SOLICITATION AMENDMENT / MODIFICATION DE L'INVITATION

Solicitation No. / Nº de l'invitation W6369-23-A083 Date of Amendment / Date de la modification November 23 2023 Address Enquiries to / Adresser toutes questions à: Att: Joanne Dubeau Department of National Defence Director Services Contracting (D Svcs C 3) 101 Colonel By Drive Ottawa, Ontario K1A 0K2 Email: joanne.dubeau@forces.gc.ca Telephone No. / Nº de téléphone FAX No. / Nº de fax Destination Department of National Defence Central Medical Equipment Depot 105 Montgomery Rd, Bldg: BB-104A Garrison Petawawa Pertawawa ON	Title / Titre	
Solicitation No. / N° de l'invitation W6369-23-A083 Date of Amendment / Date de la modification November 23 2023 Address Enquiries to / Adresser toutes questions à: Att: Joanne Dubeau Department of National Defence Director Services Contracting (D Svcs C 3) 101 Colonel By Drive Ottawa, Ontario K1A 0K2 Email: joanne.dubeau@forces.gc.ca Telephone No. / N° de téléphone FAX No. / N° de fax Destination Department of National Defence Central Medical Equipment Depot 105 Montgomery Rd, Bldg: BB-104A Garrison Petawawa	Pharmacy Refrigerators

AMENDMENT 1 TO SOLICITATION NUMBER W6369-23-A083 IS RAISED TO:

6. Amend MTC 4.4, on page 17/39

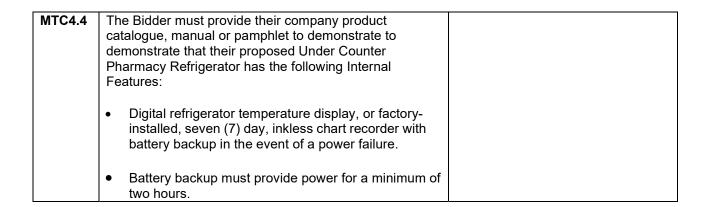
DELETE MTC 4.4, on page 17/39 in its entirety, and replace with the following:
